Nature of Work: REPLACE BURNT GARAGE WITH NEW, REPAIR DAMAGE TO RESIDENCE

Job Name: FIRE REPAIR

TRUSS ENGINEERING DRAWING PACKAGE

RE: Re-roof at Montez Residence, 2831 Carberry Way, Sacramento, CA.
This letter is our Job # 01-1357.

— TOP VIEW —
 floor plan

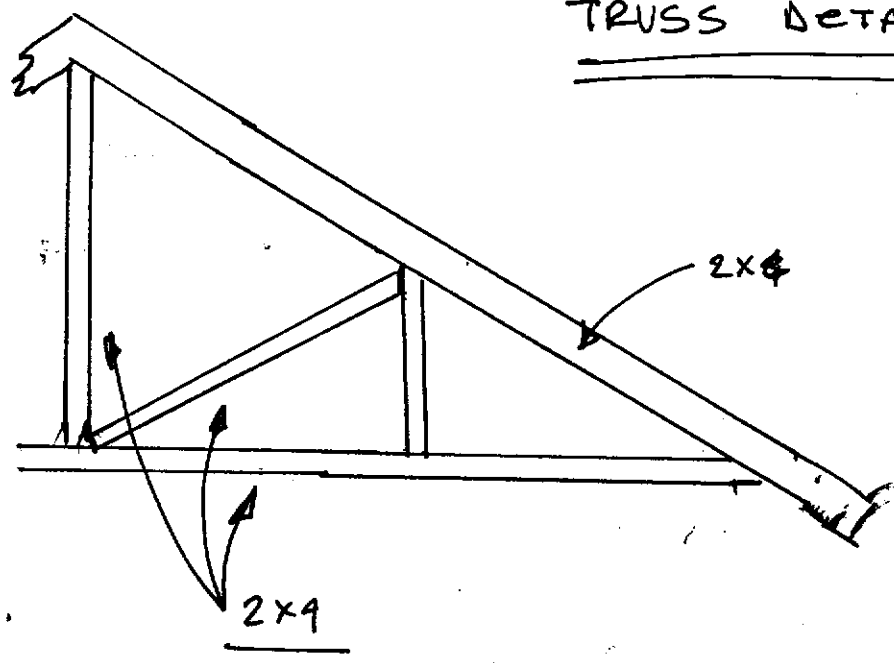
PROVIDE TRUSS TO INSPECTOR FOR APPROVAL
 ENGINEER IN THE FIELD
 Phil Reed
 1/12/01

SKETCH OF ROOF FRAMING

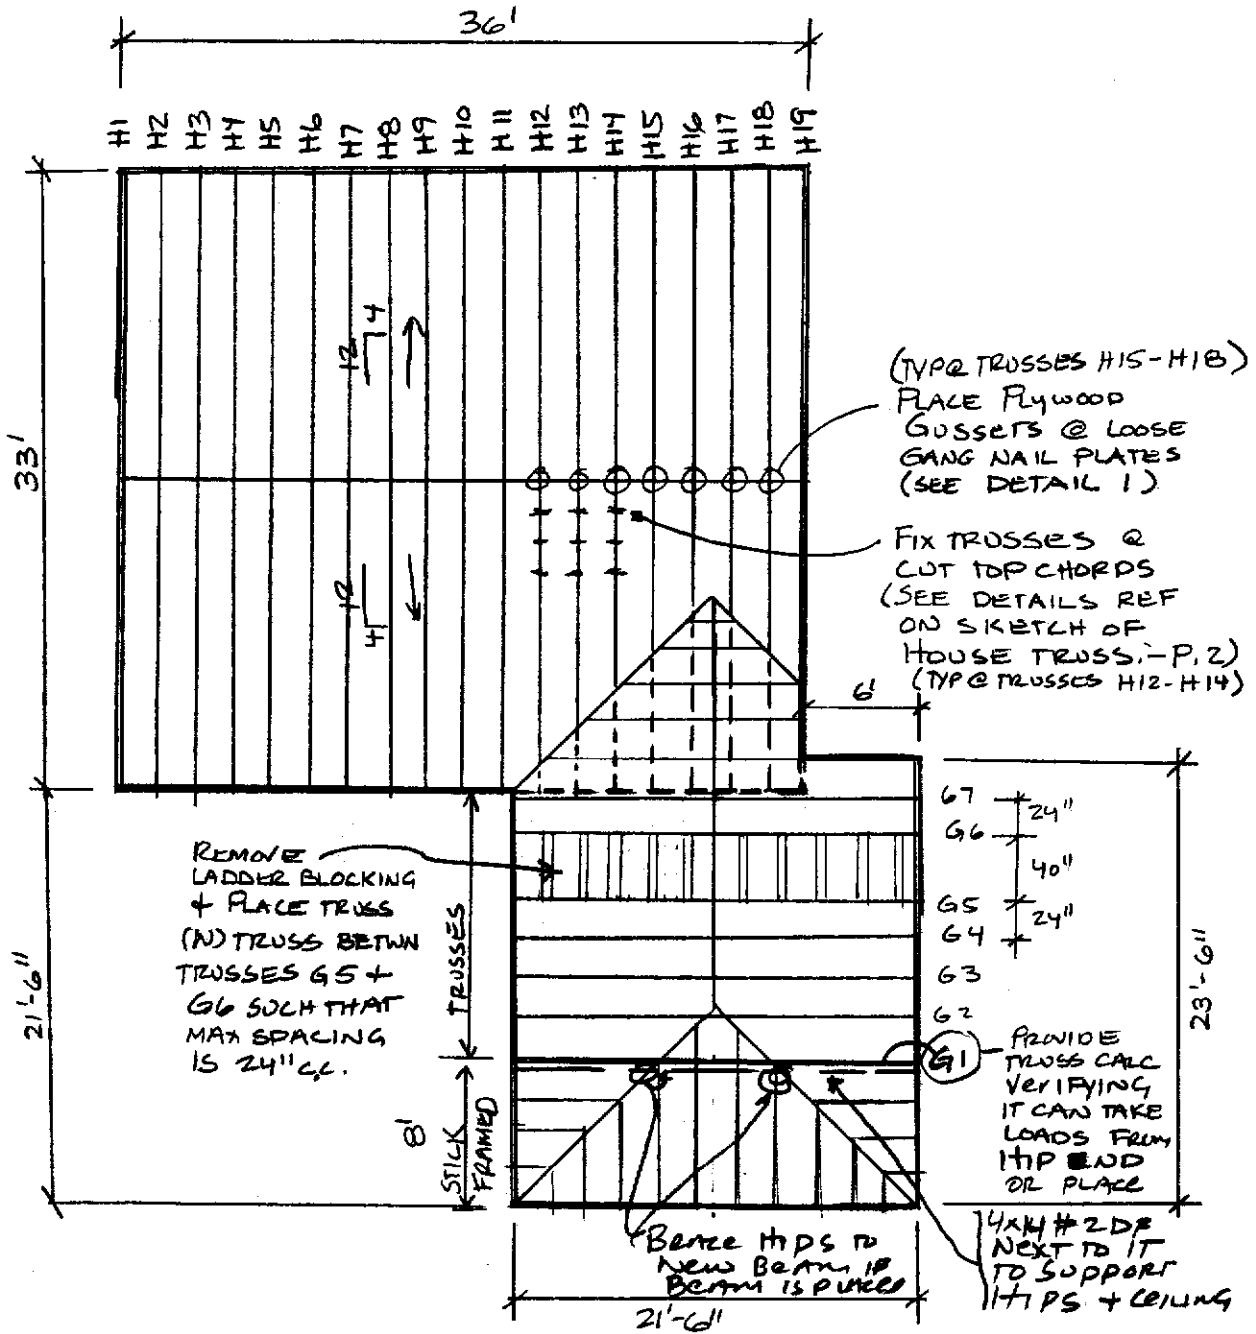
On Trusses H12 thru H19 (shown on roof sketch on Attachment 1), the nail plates at the ridge point were loose. On Trusses H12 thru H14 (three trusses) there were cuts in the top chord where the fire fighters had cut holes in the roof and the nail plates were loose. On trusses H15 thru H19 just the nail plates at the ridge were loose.

- 1) Between Trusses G5 and G6 (as shown on the roof sketch on page 1 of the attachment) there was a 40" space, with ladder blocking at 16" c.c.. This is not acceptable, it

overloads the trusses on either side. An additional truss must be placed such that the maximum spacing between the trusses is 24".

- 2) Truss G1 (as shown on the roof sketch on page 1 of the attachment) approximately 8' back from the front of the garage, it must be verified that it is designed to act as a girder truss that can support the additional framing from the hip end. At the time of my inspection I did not see any paper work verifying that it was designed as a girder truss. If it not designed as a girder truss then it is to be replaced with one that is or a beam may be placed adjacent to it that will support the hips and ceiling members. If a beam is to be used – it should be a 4x14 #2DF with the ends to cut to match the depth and slope of the roof.

On trusses H12, H13, and H14 – the top chord is to be replaced and the ridge point reinforced as shown in Details 1 and 2 as shown on pages 2 and 3 of the attachment.

On trusses H15, H16, H17, H18, and H19 – the ridge point is to be reinforced with plywood gussets as shown in Detail 1 on page 2 of the attachment.

① DETAIL - RIDGE PT. REPAIR @ LOOSE TRUSS M
 N.I.S.

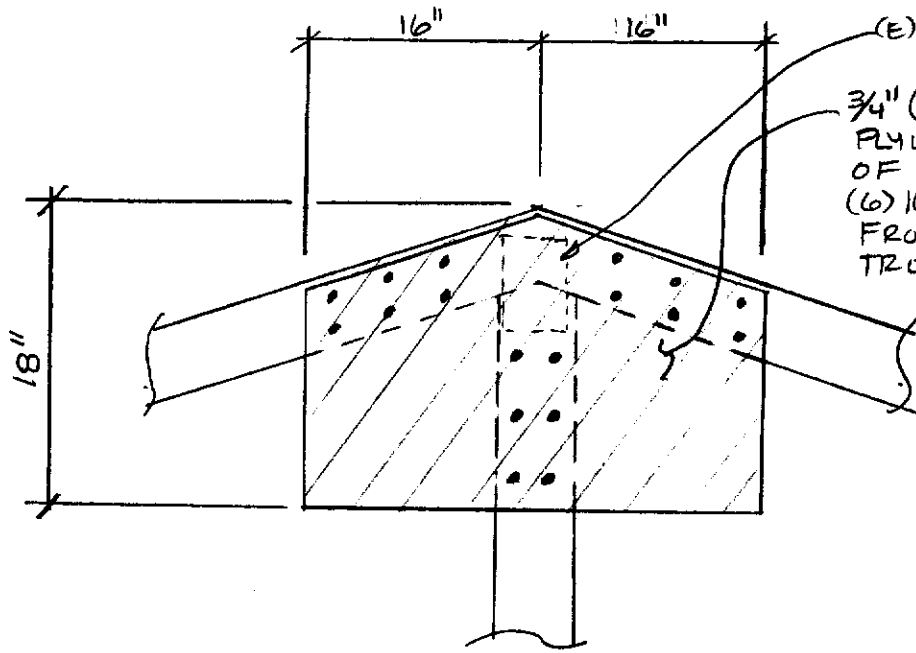
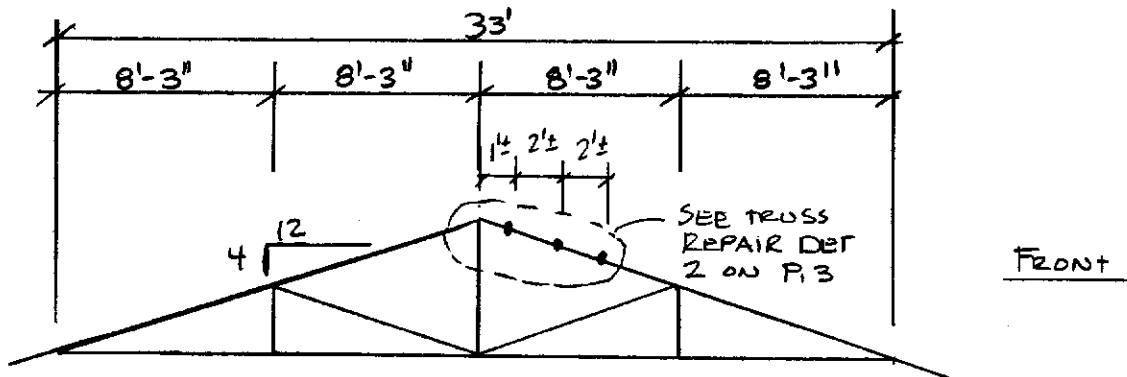
(E) LOOSE TRUSS M'S

3/4" (23/32" MIN) APA RATED
 PLYWOOD-TYP BOTH SIDES
 OF EA TRUSS, w/
 (6) 10d COMMON NAILS
 FROM EA. SIDE TO EA.
 TRUSS MEMBER,
